APPENDIX F

PUBLIC CONSULTATION ACTIVITIES

Prospect Park Well Field Re-Rating and Water Purification Plant Expansion Class Environmental Assessment Agency and Stakeholder Contact List

Municipal Class Environmental Assessment Study Prospect Park Well Field Re-Rating and Water Purification Plant Expansion Town of Halton Hills (Acton) PR-2221

Figure 4 - Current and Projected Lake Levels

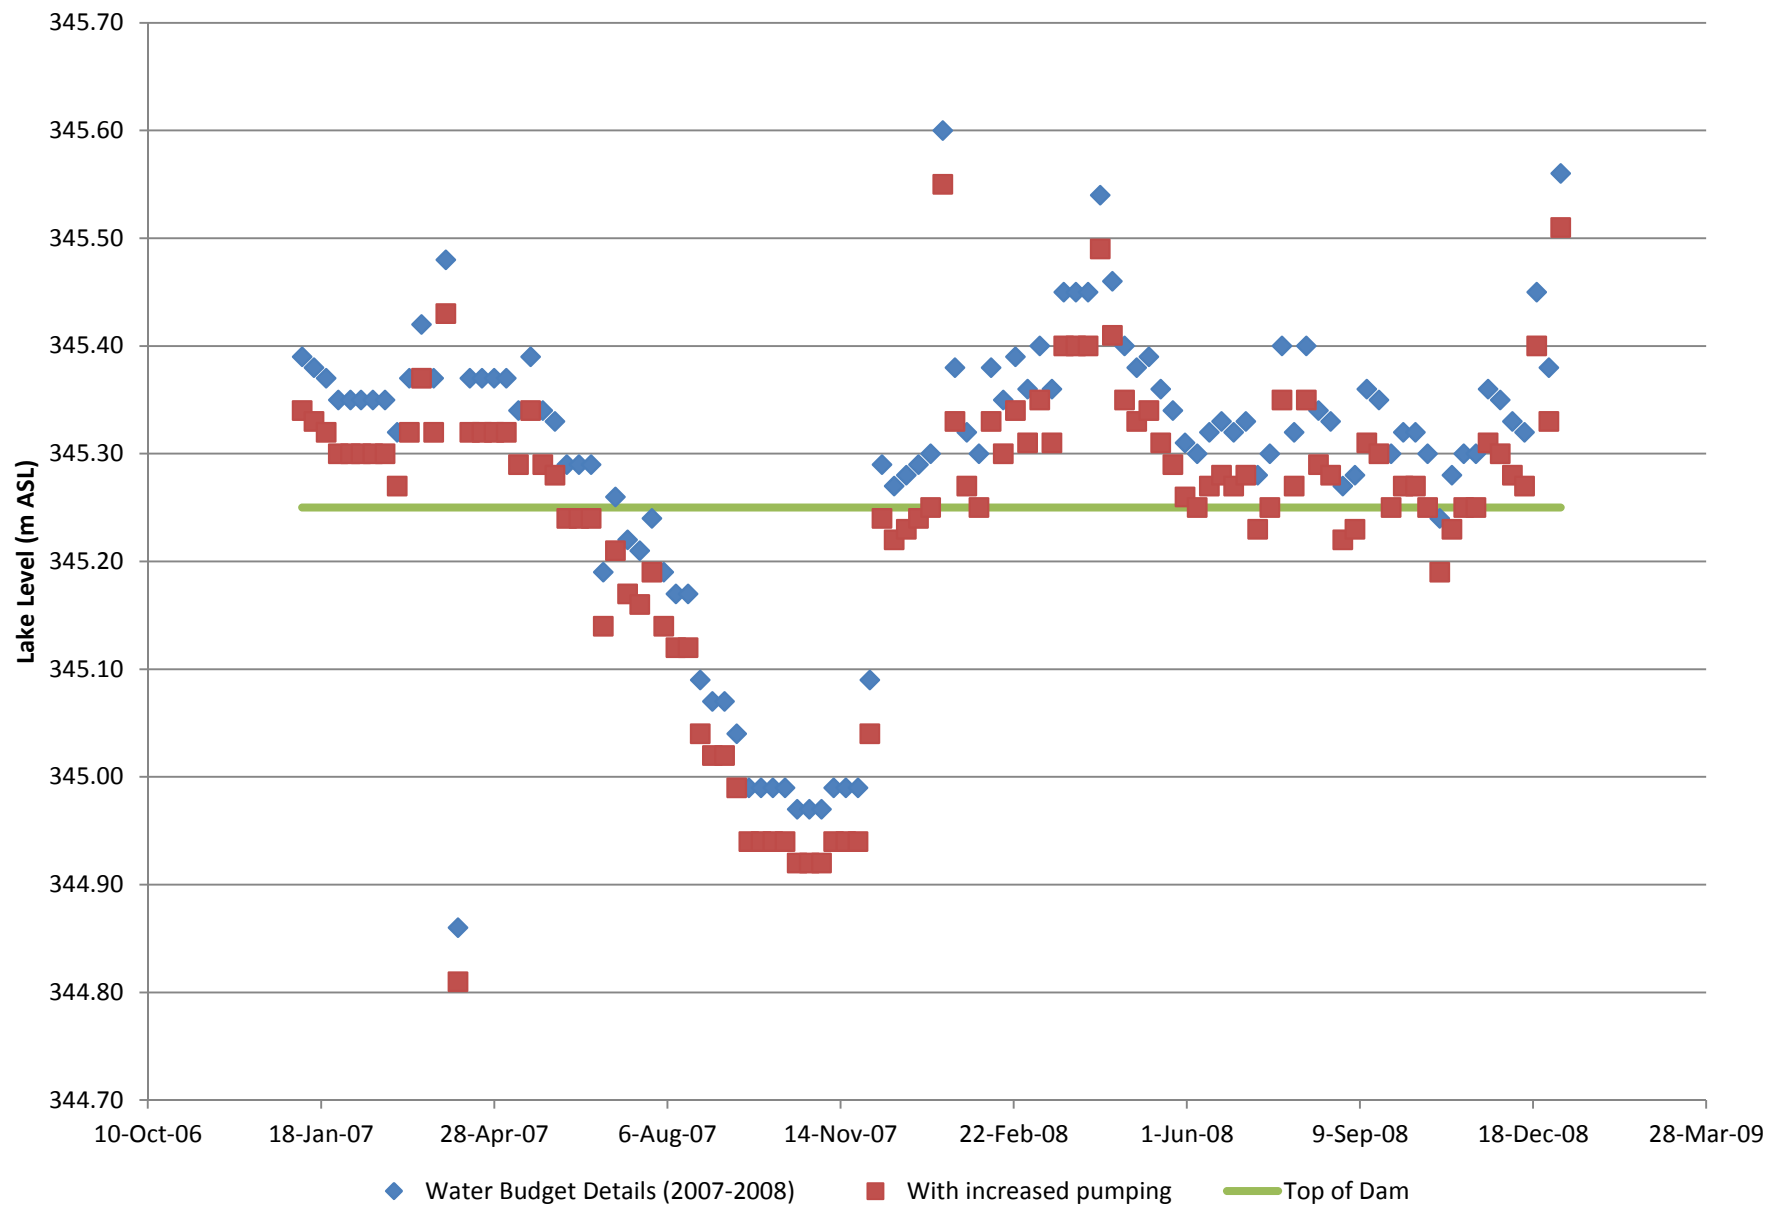
The data indicate that seasonal variation in lake levels are in the range of 0.4 to 0.6 m, with lower levels experienced in the summer months. The data also suggests that lake levels are heavily influenced by surface water inflow (as shown in Figure 5, Appendix C), and the amount of inflow is dependent on the amount of precipitation (as shown in Figure 6, Appendix C). The data support the assertions in the Impact Assessment Report that the impacts of increased groundwater takings will not have a significant impact on surface water levels.

FIGURE: 11

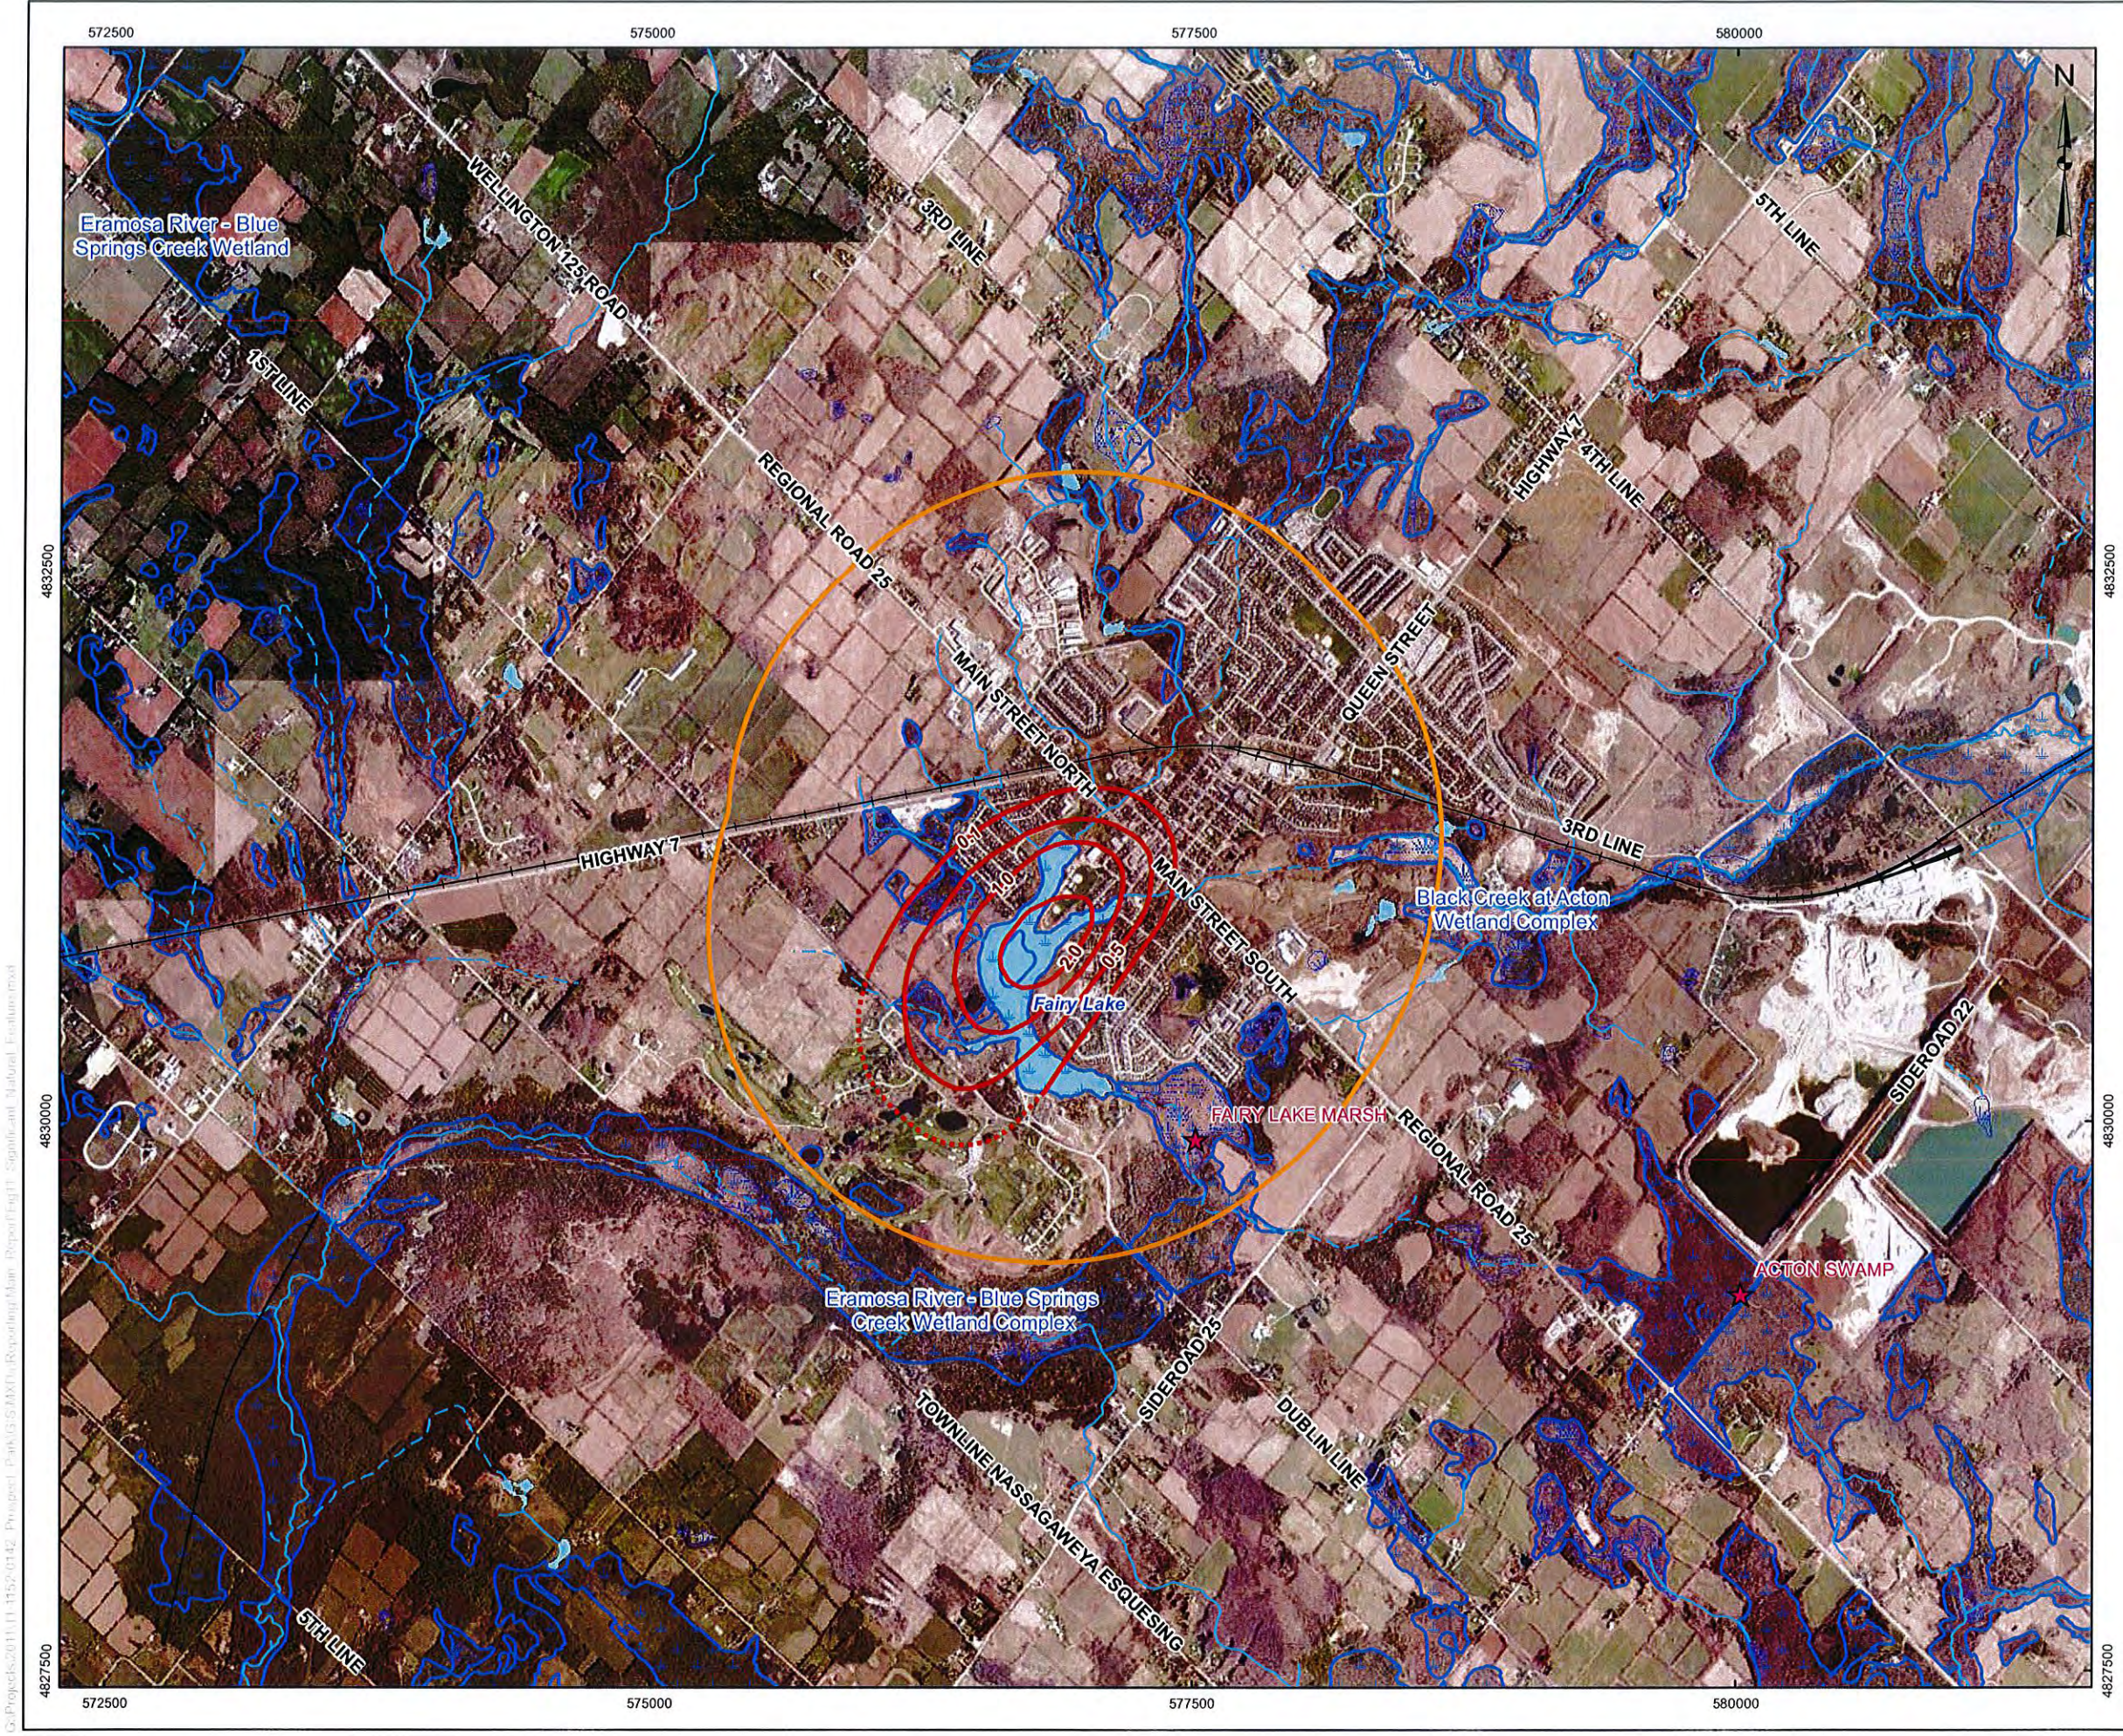
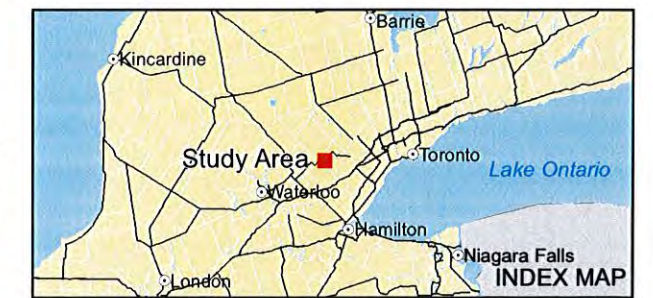
Please see response to Comment 6 above. The zone of influence indicates that there was negligible drawdown in the aquifer and shallow groundwater zones beyond Fairy Lake. See Figure 11 in the Golder (2012) report (attached in Appendix C).
